# Proposed Revisions DBNGP Access Arrangement

*2016 – 2020 Access Arrangement Period  
Supporting Submission: 57  
Response to Draft Decision Other Tariff Amendments*

*Date Submitted: 22 February 2016*

*DBP Transmission (DBP) is the owner and operator of the Dampier to Bunbury Natural Gas Pipeline (DBNGP), Western Australia's most important piece of energy infrastructure.*

Example 1 – Total Deliveries exceed Full Haul Capacity (ignoring losses and system use gas)

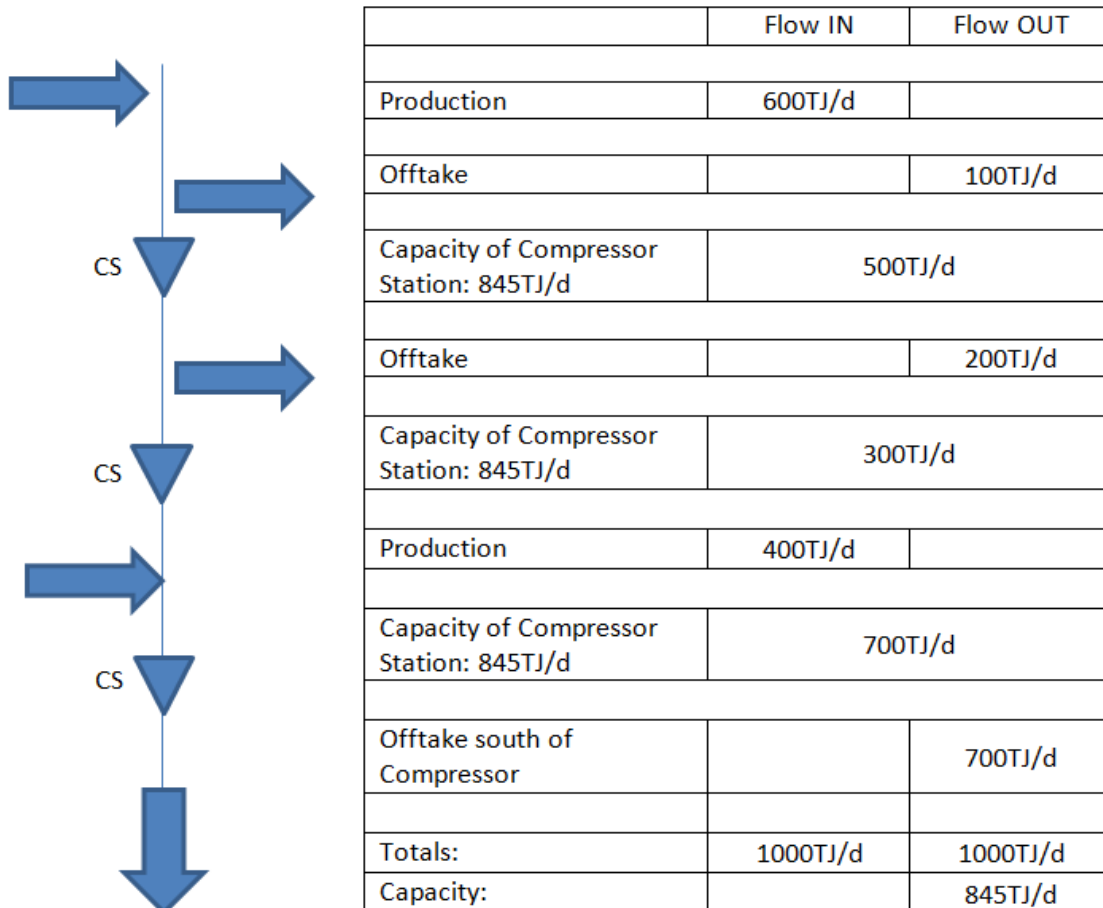
Production from the first facility that is delivered into the pipeline at the relevant inlet point is assumed at 600TJ/d with an off-take of 100TJ/d at one or more outlet points upstream of the first compressor station. The gas flows downstream and reaches the first compressor station (which has capacity of 845TJ/d) but only 500TJ/d of gas passes through the compressor station and so, the compressor station has unutilised capacity.

Downstream of the second compressor station is a second production facility which delivers into the pipeline at a relevant inlet point an amount of 400TJ/d of gas. The third compressor station can accept all this gas and has unutilised capacity. 700TJ/d flows through this compressor station and is then delivered to a variety of customers downstream.

Based on this scenario, a total amount of 1000TJ/d has been delivered at all outlet points on the pipeline (being part haul and full haul outlet points).

Example 2 –Constrained system

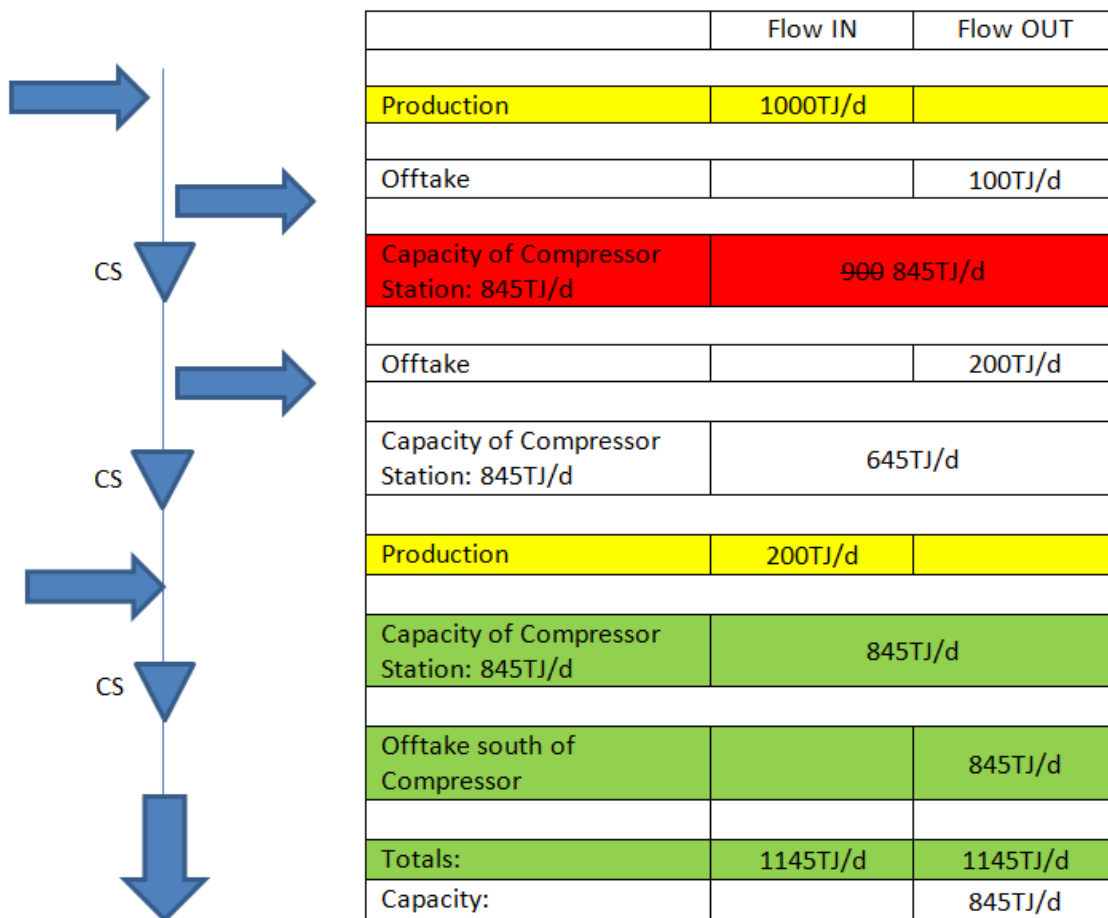
Note that production from the first facility is now 1000TJ/d (highlighted yellow). Off-take at relevant outlet points downstream of this facility is still 100TJ/d, so 900TJ/d is available to pass through the first compressor station. However, as the compressor station has a capacity of 845TJ/d, the compressor station is unable to move (900-845) 55TJ/d and so the first production facility would reduce deliveries to 945TJ/d. Alternatively deliveries at outlet points upstream of the first compressor station could increase by 55TJ.

Note that in this constrained situation, the pipeline still delivers to all outlet points (both part haul and full haul outlet points) a total amount that exceeds the pipeline’s full haul capacity, delivering 1145TJ/d and running the first and third compressor station at its design capacity.

Note that the second off-take could not exceed 845TJ/d unless the second compressor station was designed to operate in a bi-directional mode.

Example 3 –Full Haul Capacity constrained (ignoring losses and system use gas)

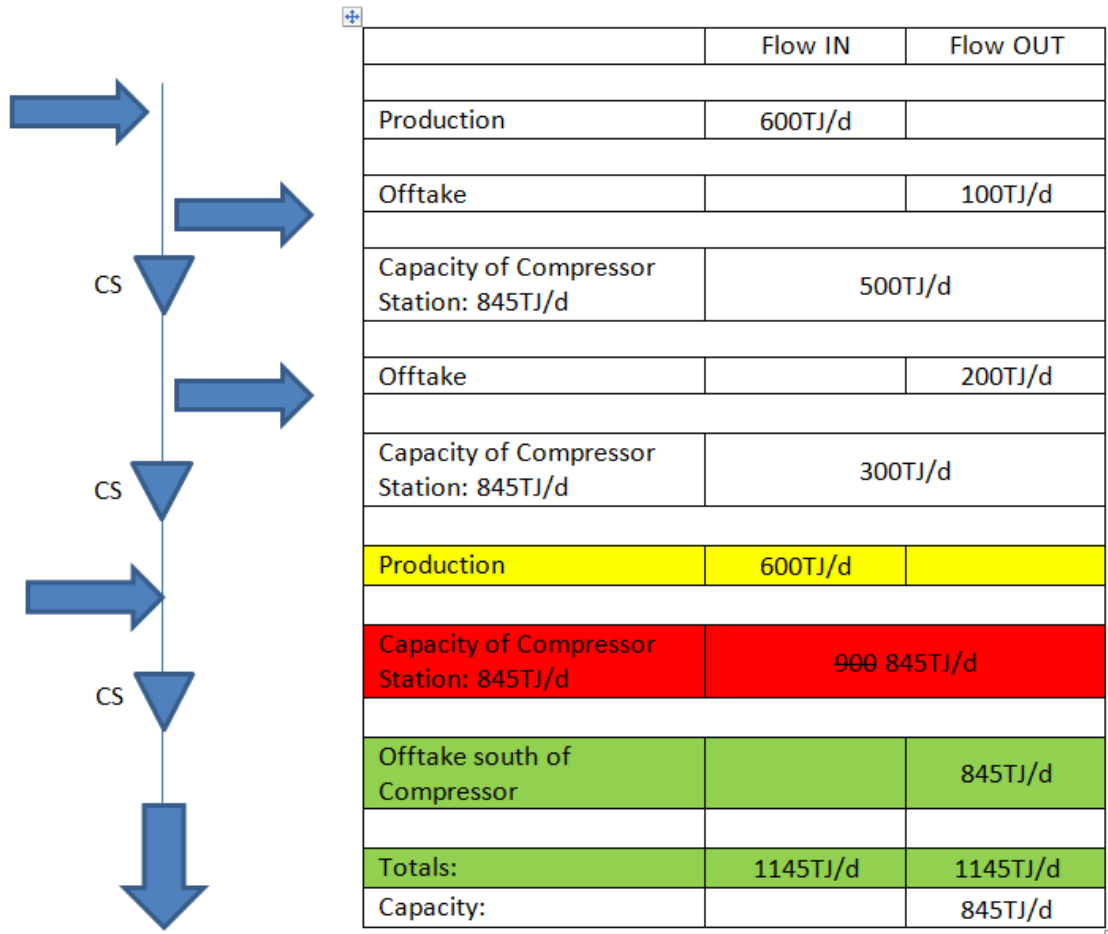
Note that production from the second facility (highlighted yellow) is now increased so that 600TJ/d (up 200TJ from Example 1) is delivered into the pipeline at the relevant inlet point. This would ordinarily mean that flow into the third compressor station is 900TJ/d, but this compressor has a capacity of 845TJ/d and so only 845TJ/d of gas will flow downstream of the compressor station. For the purposes of the example it is assumed there is demand of 845TJ/d downstream of this compressor station.
